Point Beach Nuclear Plant, Units 1 and 2
Dockets 50-266 and 50-301
License Nos. DPR-24 and DPR-27

License Amendment Request 245, Response to Request for Additional Information;
Technical Specification 3.3.4, Loss of Power Diesel Generator Start and Load
Sequence Instrumentation

RESPONSE TO REQUEST FOR ADDITIONAL INFORMATION LICENSE AMENDMENT REQUEST 245 TECHNICAL SPECIFICATION 3.3.4, LOSS OF POWER DIESEL GENERATOR START AND LOAD SEQUENCE INSTRUMENTATION

POINT BEACH NUCLEAR PLANT, UNITS 1 AND 2

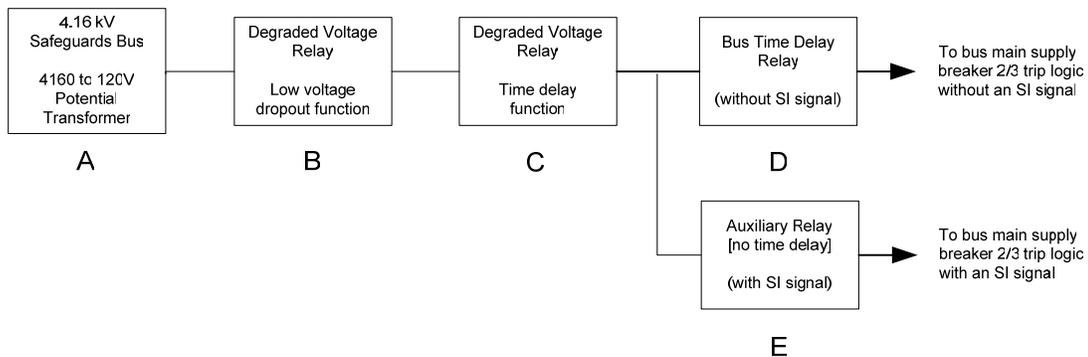
NMC’s justifications for changing the wording in SR 3.3.4.3b from “with SI signal present” to “bus degraded voltage relay” and from “without SI signal present” to “bus time delay relay,” is not clear to the NRC staff. The NRC staff believes that the current wording is clear and is consistent with Branch Technical Position PSB-1 which clearly requires two-time delay functions one with and the other without SI signal. Provide additional justification for this proposed change.

The purpose of the proposed terminology change is to reduce ambiguity in the conduct of the surveillance requirements. The terminology change does not alter any surveillance requirements, it merely clarifies existing requirements. Two time delay functions, one with and the other without a SI signal, will continue to be required by the SR.

- (1) The “with SI signal present” time delay is synonymous with the bus degraded voltage relay (Block C Relay) time delay that actuates the degraded voltage protection if an SI signal is present coincident with degraded voltage;
- (2) The “without SI signal present” time delay consists of the sum of the bus degraded voltage relay (Block C Relay) delay plus the bus time delay relay (Block D Relay) delay that occur in series if degraded voltage exists during normal plant operation.

This series relationship of the Block C and Block D relays is shown in Figure 1 of Calculation 2004-0002 (see Enclosure 2) and in the following relay block diagram:

Please note that the above diagram clarifies (and differs from) the corresponding diagram in the March 23, 2006 submittal (Reference 1). Relay Blocks D and E in the above diagram are reversed from those shown in the original submittal. The clarification to Blocks D and E was made to align this diagram with Figure 1 in Calculation 2004-0002 so that Block D represents the bus time delay relay without an SI signal present. (Only the above description was revised; the physical relay arrangement remains unchanged.)

Figure 1: Degraded Voltage Protection Loop Block Diagram:

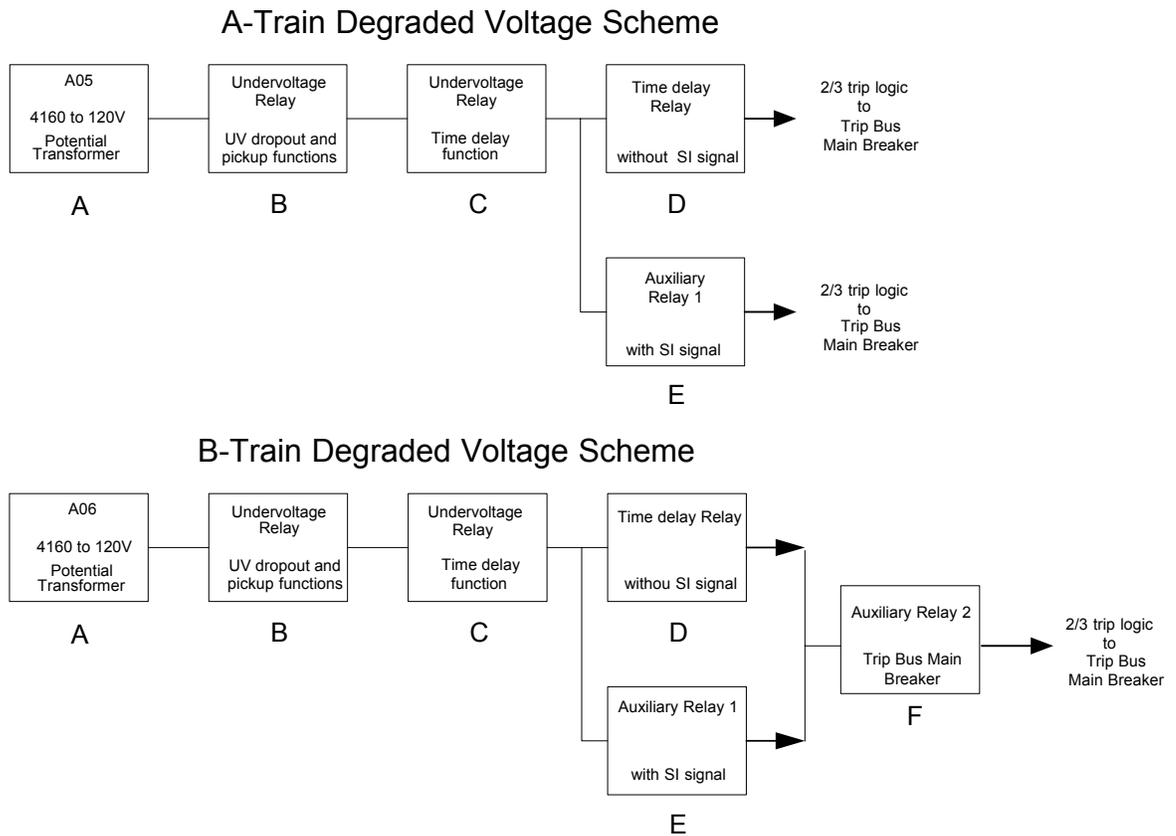
Setpoint Calculation Methodology: Provide documentation (including sample calculations) of the methodology used for establishing the limiting setpoint (or nominal trip setpoint, NSP) and the limiting acceptable values for the as-found and as-left setpoints as measured in periodic surveillance testing as described below. Indicate the related analytical limits and other limiting design values (and the sources of these values) for each setpoint.

1. Methodology section (Pages 45, 50-51, 69 - 82 of Calc 2004-0002)
Applicable Items: Figure 1, Eq. 1 (pg. 50), Eq. 2 (pg. 51), and Section III.2.10
2. Assumption Section (Pages 86 - 89 of Calc. 2004-0002)
Applicable Items: Section III.4.01 - III.4.03, and III.4.05 - III.4.08

Figure 1, in Section III.2.06, is a block diagram of the components that makeup each 4.16 kV safety related bus degraded voltage protection loop on both units. There are two buses (A-train and B-train) per unit. There are three independent loops per bus that supply a two-out-of-three coincidence logic (twelve independent loops total). This section describes the time delay set points established by blocks C, D and E.
